APPLICATION NO: 22/00898/CONDIT		OFFICER: Mr Ben Warren
DATE REGISTERED: 18th May 2022		DATE OF EXPIRY: 13th July 2022
WARD: Prestbury		PARISH: PREST
APPLICANT:	Mr Tom Hunting	
LOCATION:	3 Finchcroft Lane Cheltenham Gloucestershire	
PROPOSAL:	Variation of condition 2 (approved plans) on planning permission 21/00256/FUL - amendments to front dormers and changes to front elevation fenestration arrangement (retrospective)

Ref: 21/00256/FUL Amendment to Planning Application for 3 Finchcroft Lane, Prestbury.

Photo A

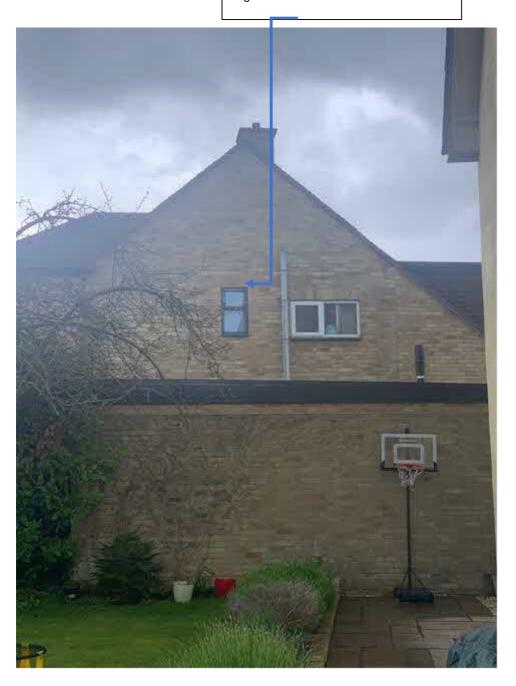
- Direct impact on the privacy in our garden being compromised. This additional view
 point directly overlooks our private garden and is overbearing. The existing and new
 windows are not as per the scale on the "approved" plans. The new window is
 extending beyond the height in the "approved" plans. Please see Photo A –
 Appendix.
- Obscured glazing is required to the appropriate grade, and fixed shut to limit intrusion of our privacy.
- Furthermore, the internal floor plans for the first floor do not reflect the proposed amendment layout. The internal wall on the "approved" plans appears to be part way through the existing window wish to be retained.

Windows are not as to "approved" drawings. Height of new window is higher.

Photo B

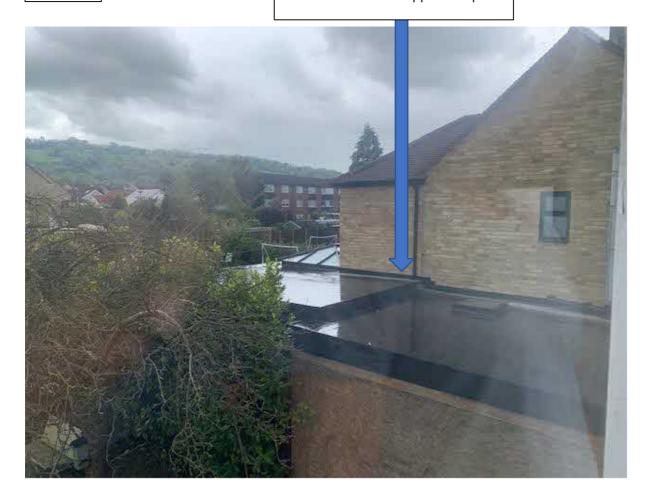
- The left elevation flat roofs are built to the two different heights, not as per the "approved" plans. Please see Photo B Appendix.
- The roof lantern is currently built in a different position to that on the "approved" plans. Please see Photo C Appendix.
- There is a window built currently within one of the flat roof areas. This is not visible on the "approved" plans. Please see Photo D Appendix.

Flat roof – two height levels are different to that of "approved" plans

Photo C

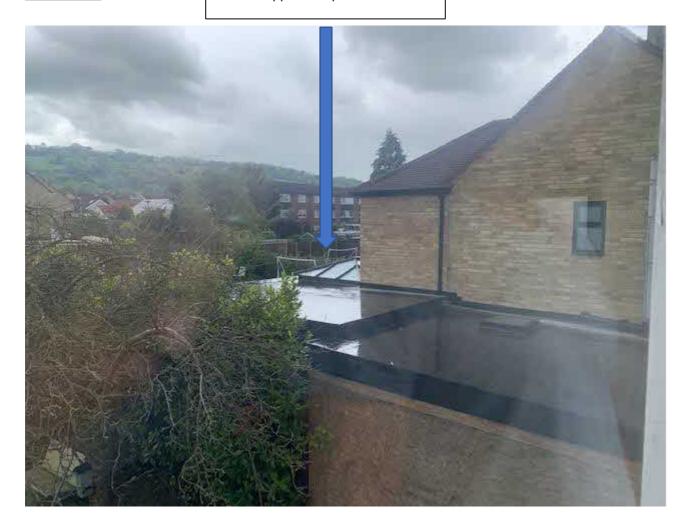
Roof lantern– position different to that of "approved" plans
